LEVEL 2 REMODEL
SECTORS 5A, 5B & 6
COLLEGE COMPLEX
LOS MEDANOS COLLEGE
2700 EAST LELAND DRIVE
PITTSBURG, CA 94565

REQUEST FOR INFORMATION

RFI # 143

HVAC Ductwork in Restrooms 230 & 231

drawing title:
HVAC FLOOR PLAN
drawing no:
M2.0
drawing of

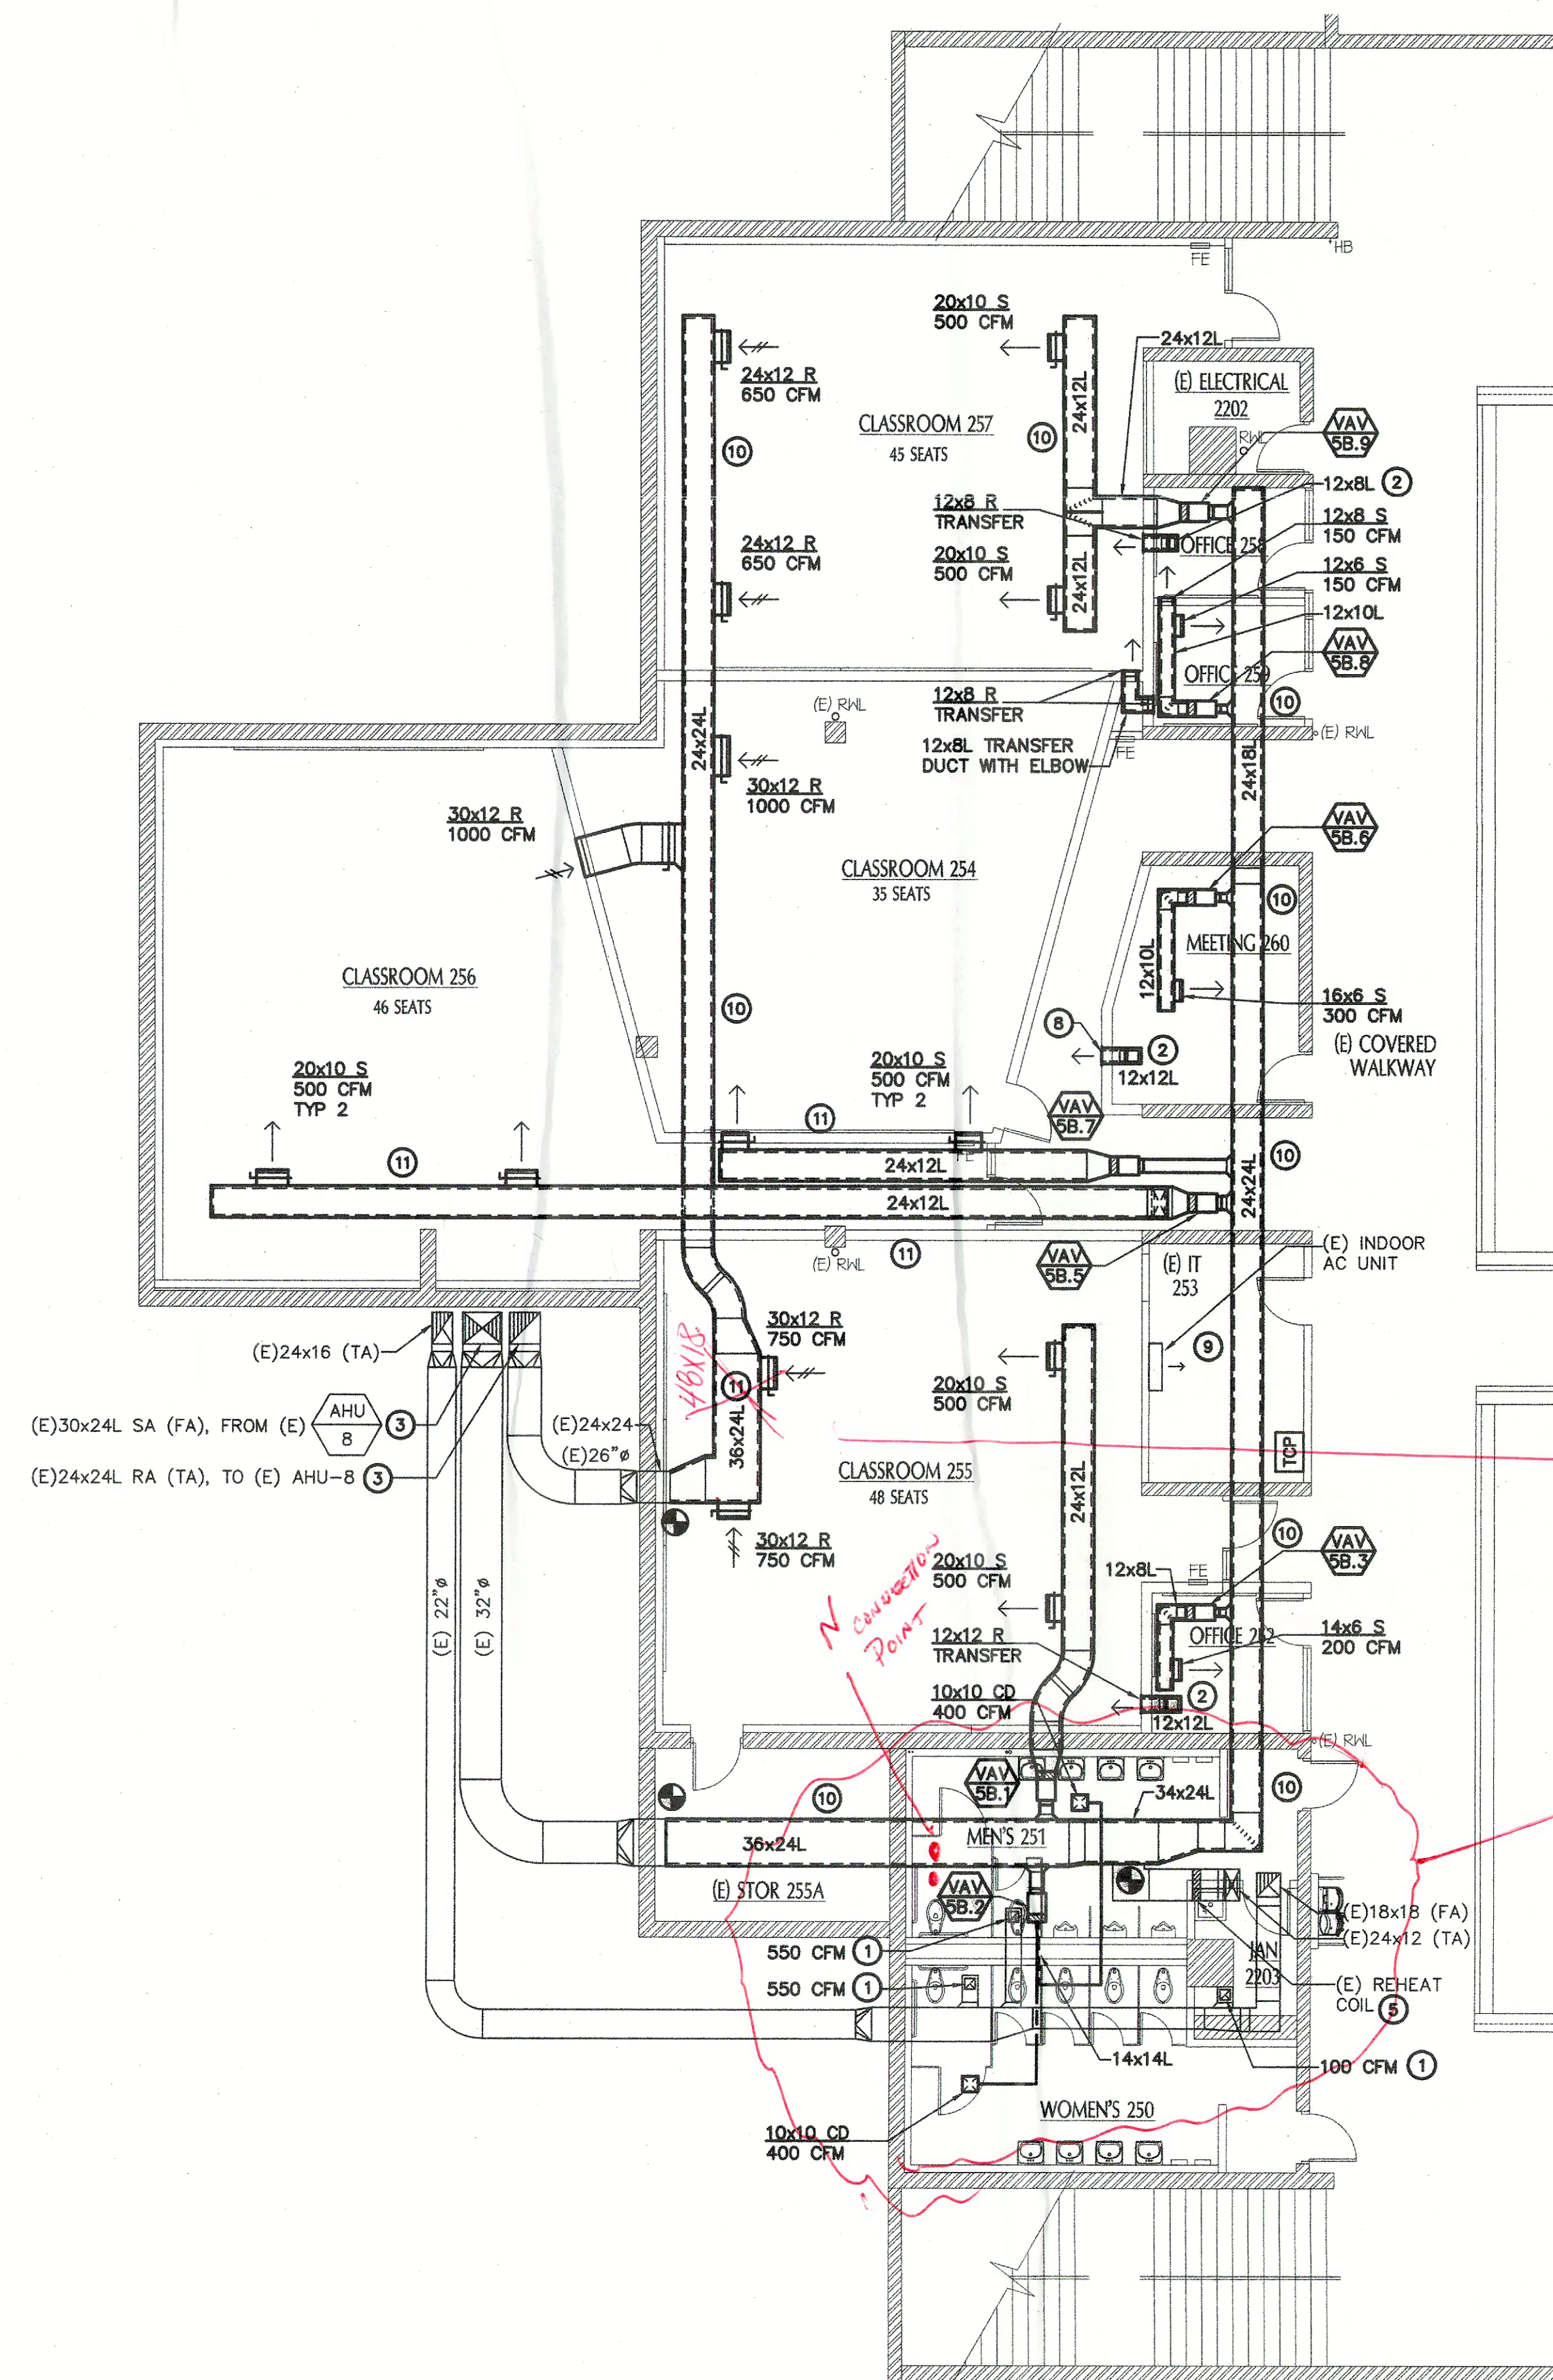
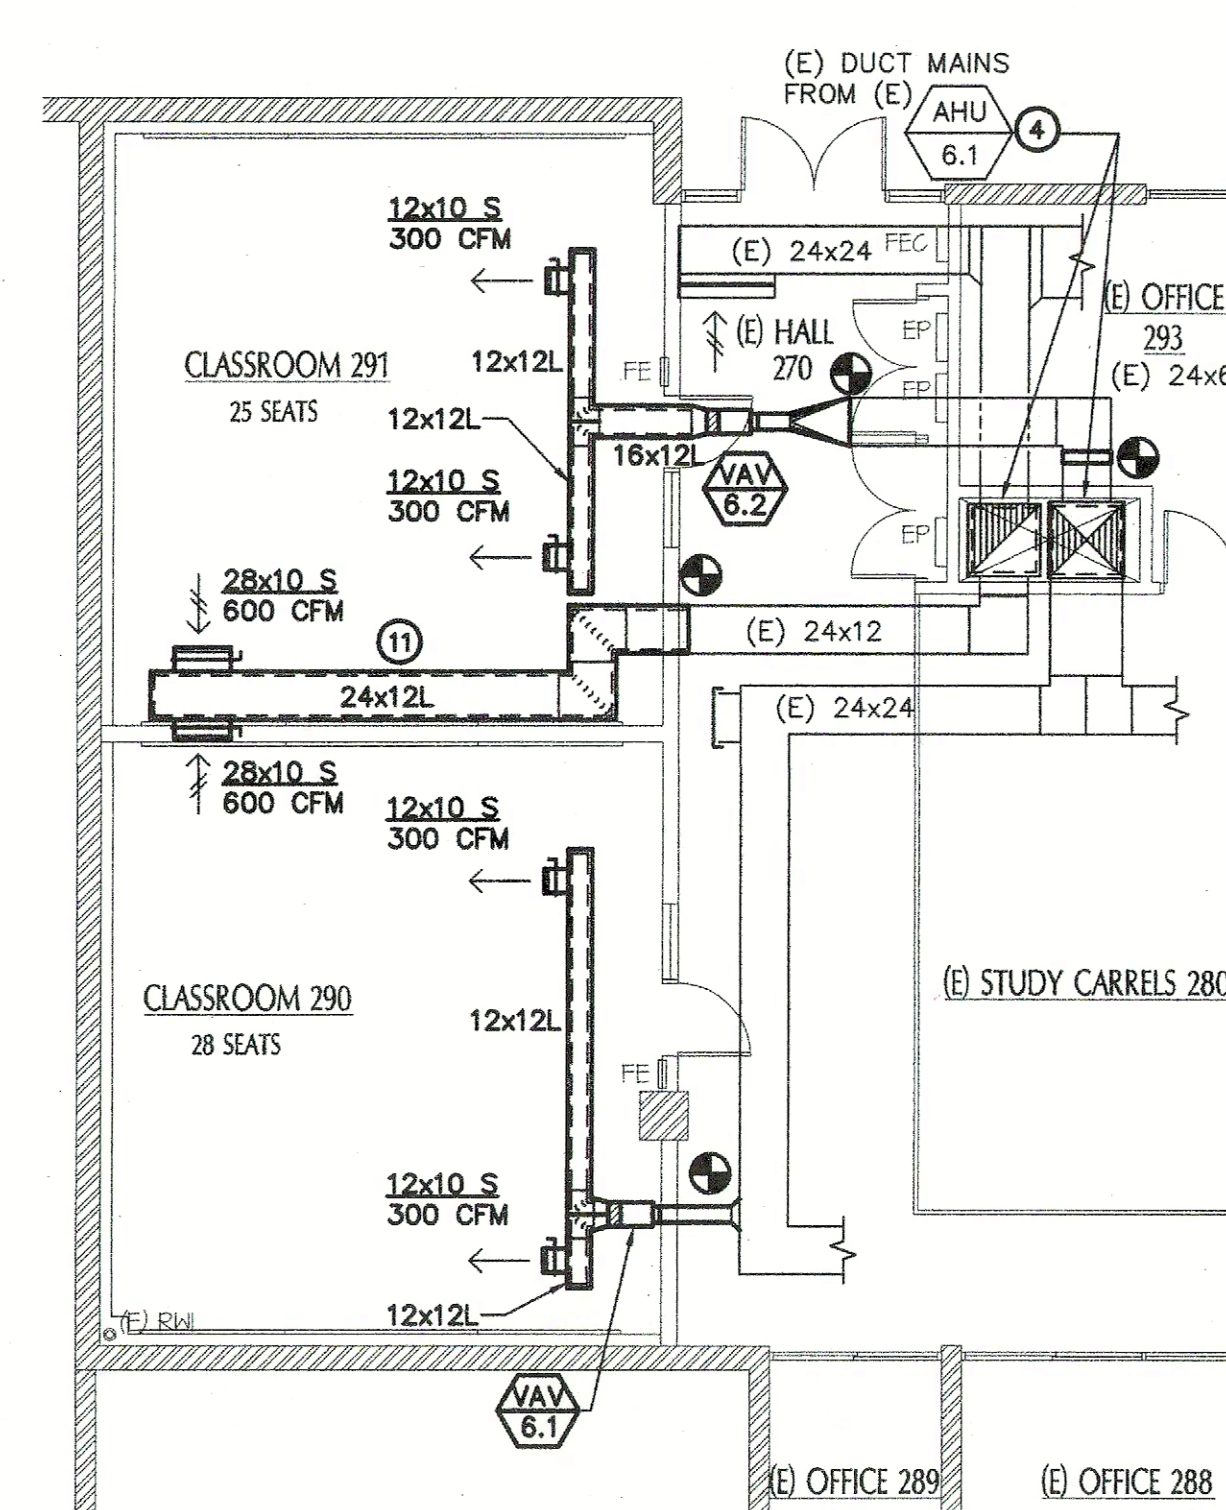
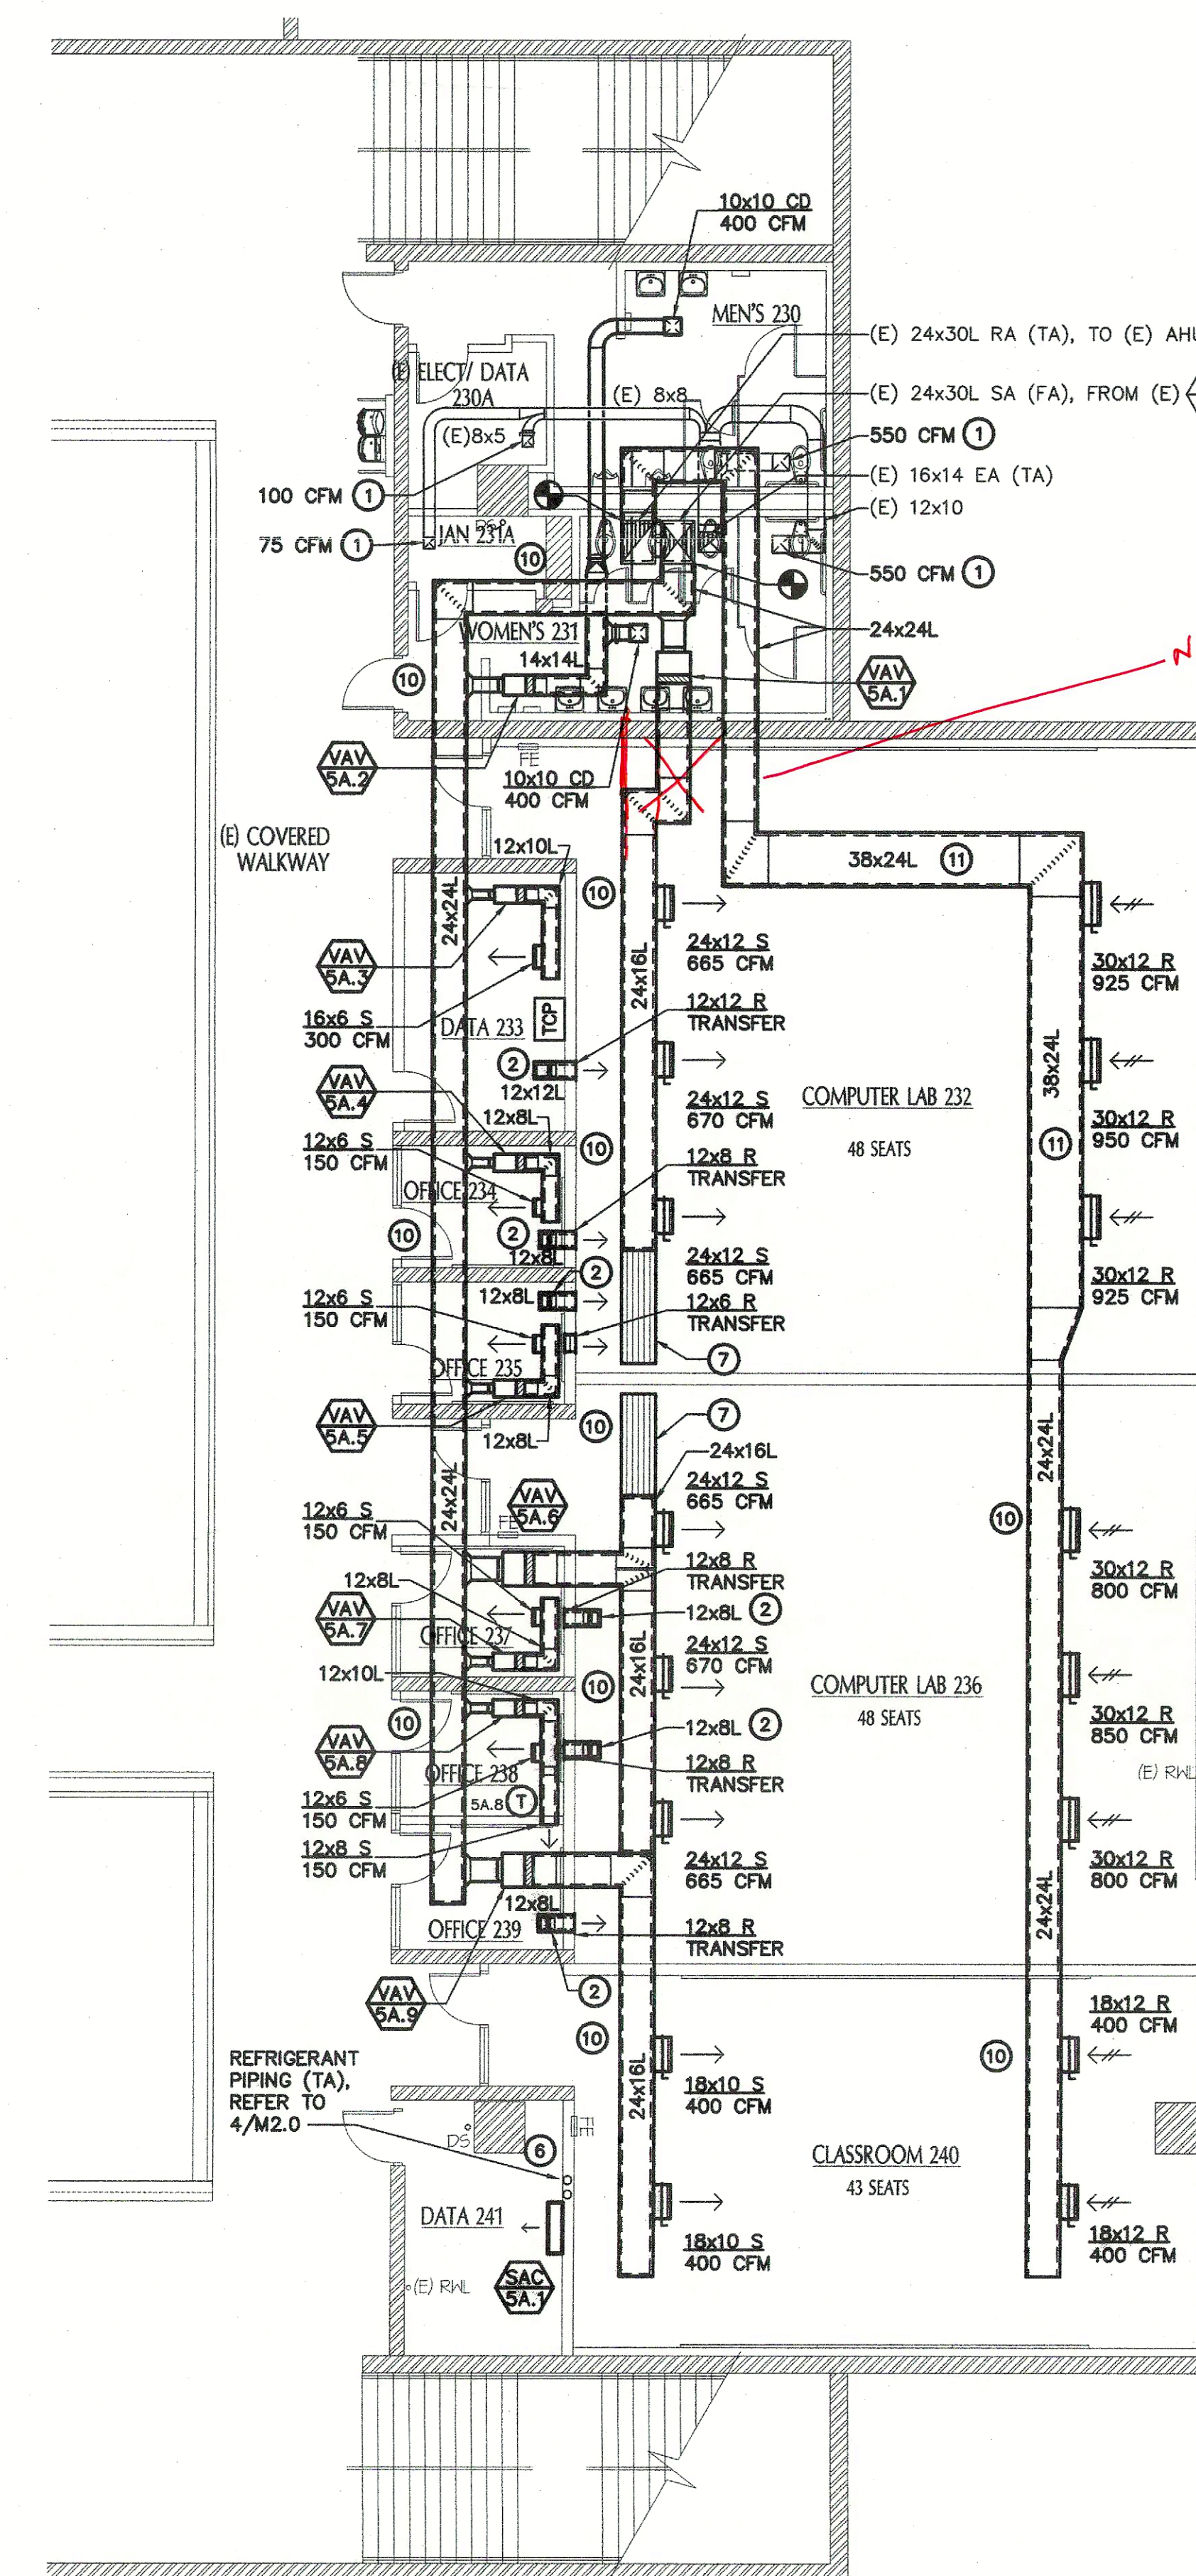
Duct work re-confirmed size/shape see ASI #5

RFA #1610 HVAC HW connection
